Commonwealth Edison
One First National Plaza, Chicago, Illinois
Address Reply to: Post Office Box 767
Chicago, Illinois 60690

Subject: Zion Station Units 1 and 2
Fire Protection
NRC Dockets 50-295 and 50-304

Description of Safe Shutdown 24 volt DC
Instrument Loop Power Supply

ARRANGEMENT OF 24 VOLT DC POWER SUPPLY
TO THE INSTRUMENT LOOP ISOLATION PANEL

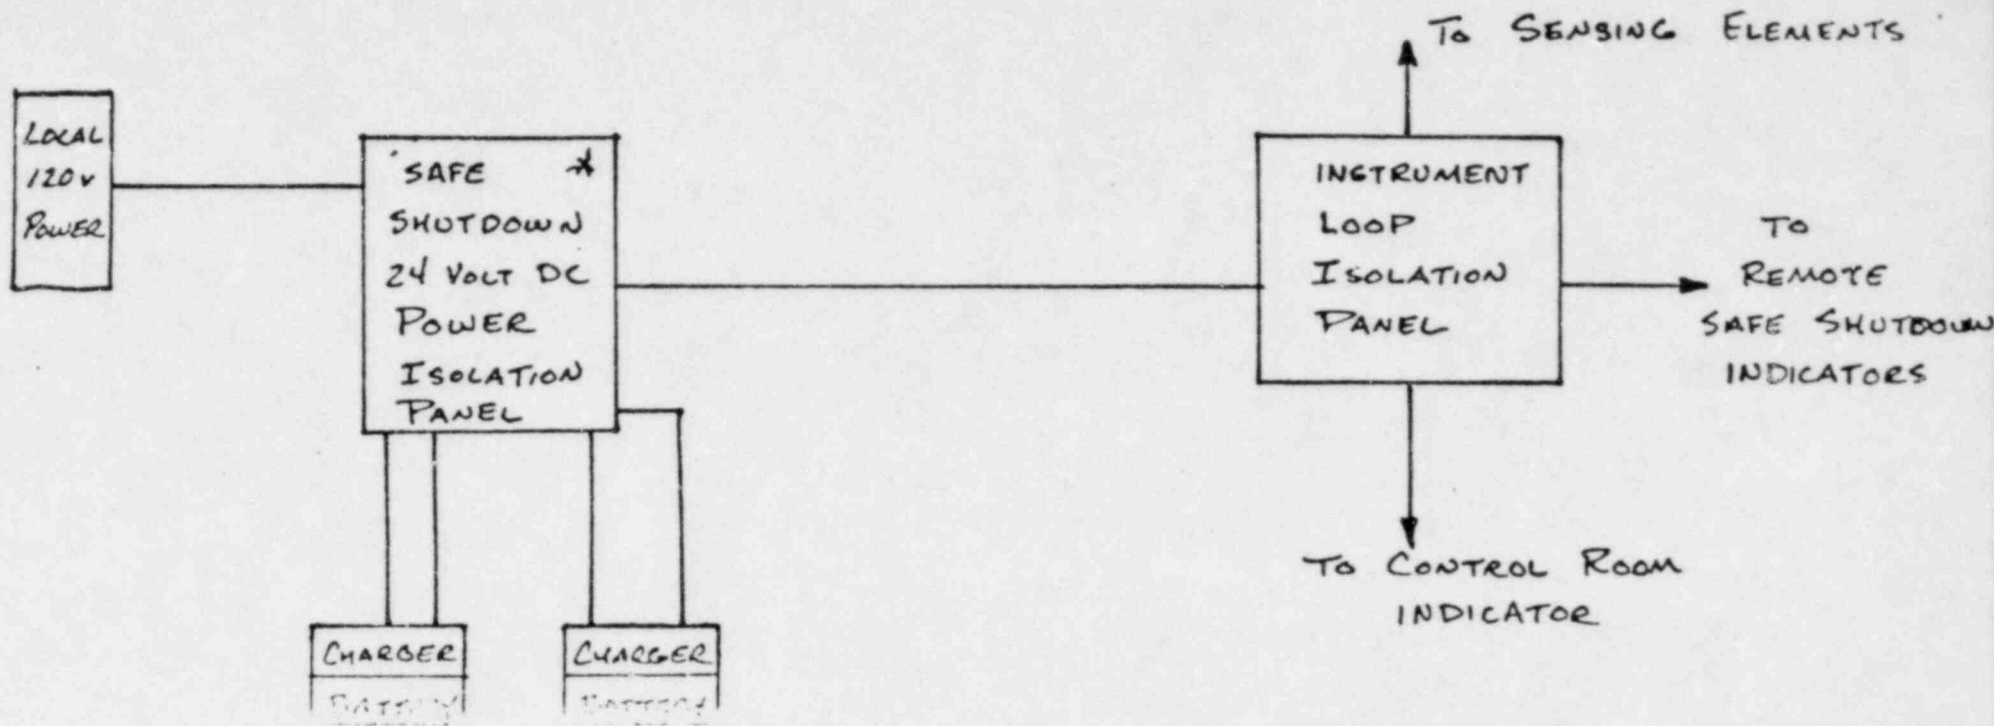
The safe shutdown 24 volt DC instrument loop power supply consists of the following equipment:

- 2 - Teledyne 12 volt 8-hour seismic battery charger units.
- 1 - 24 volt DC isolation panel.
- 1 - 3-position Electroswitch Series 20 Class 1E isolation switch.
- 1 - Westinghouse #AR880A Class 1E control relay.
- 1 - 120 volt AC power supply for battery chargers.
- 1 - Westinghouse 25 volt DC red indicating light.

This equipment is arranged as shown on the attached sketch, and its electrical connections are detailed in the DC system schematics on Drawings 22E-1-4840, Pages DC08 through DC11 for Unit 1 and 22E-2-4840, Pages DC08 through DC11 for Unit 2.

With the safe shutdown 24 volt DC instrument power isolation switch in the "NORMAL" position, 120 volt AC is supplied to the 2 battery chargers for the 12 volt DC Teledyne batteries and a control relay. This control relay isolates the 2, 12 volt batteries from each other in the normal mode to ensure that each battery is only connected to its associated 12 volt charger. This relay also ensures that no power is provided to the instrument loop isolation panel.

When the safe shutdown 24 volt DC instrument power isolation switch is in the "ISOLATION" position, the 120 volt AC power is isolated from the battery chargers and the control relay. When this control relay is de-energized, the battery chargers are isolated from the batteries; and the battery outputs are connected in series to provide 24 volt DC output. This relay also connects the battery outputs to the cable going to the instrument loop isolation panel to supply the 24 volt DC power for the local safe shutdown loop.

The "TEST" position provided on the safe shutdown 24 volt DC instrument power isolation switch is identical to the "ISOLATION" mode with the addition of a 24 volt DC indicating light added to the circuit to ensure the batteries are charged. This test will not affect the instrument loops since the loops are isolated from the 24 volt DC power supply at the instrument loop isolation panel.
